**Re: Storm Water Inspection at Delaware Health Village Phase I
Permit #4GC02678*AG**

This letter is written in follow-up to a construction storm water inspection by Amber Miller and Rachelle Howe, of the Ohio EPA, at Delaware Health Village Phase I located East of Glenn Parkway in Delaware County on September 17, 2009. The purpose of the inspection was to ensure continued compliance with the General Storm Water Permit Associated with Construction Activities. During the inspection, the following items were noted:

Figure 2

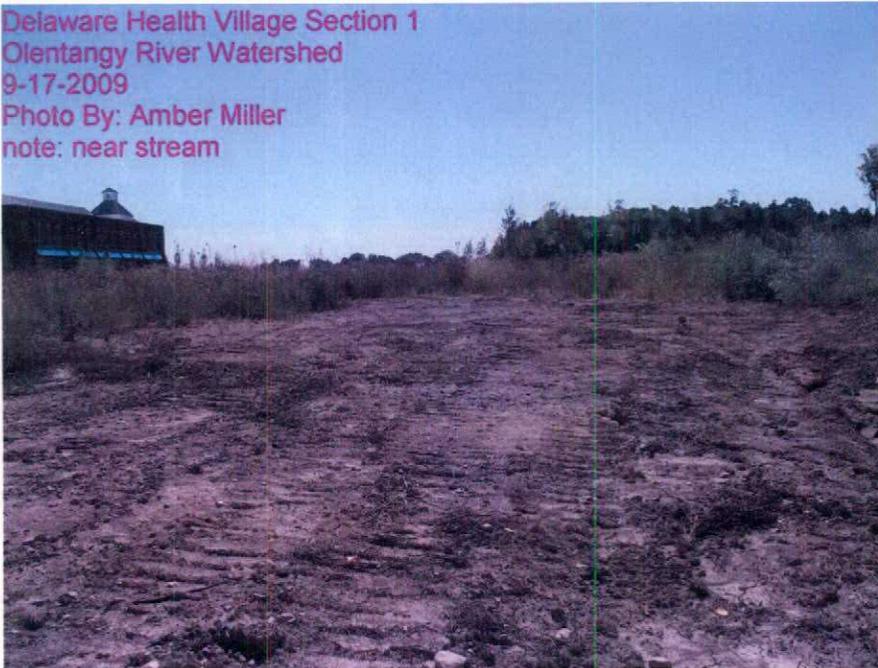
- The silt fence near the stream requires repair or reinstallation to provide adequate protection against sediment entering the stream (See Photo Figure 1).
- Be aware the General Permit states that all barren areas which remain idle in excess of 21 days must be protected from erosion within seven days of the last earth disturbing activities. In addition, erosion protection must be implemented for all areas of final grade within seven (7) days. This is especially important for the area near the stream (See Photo Figure 2).
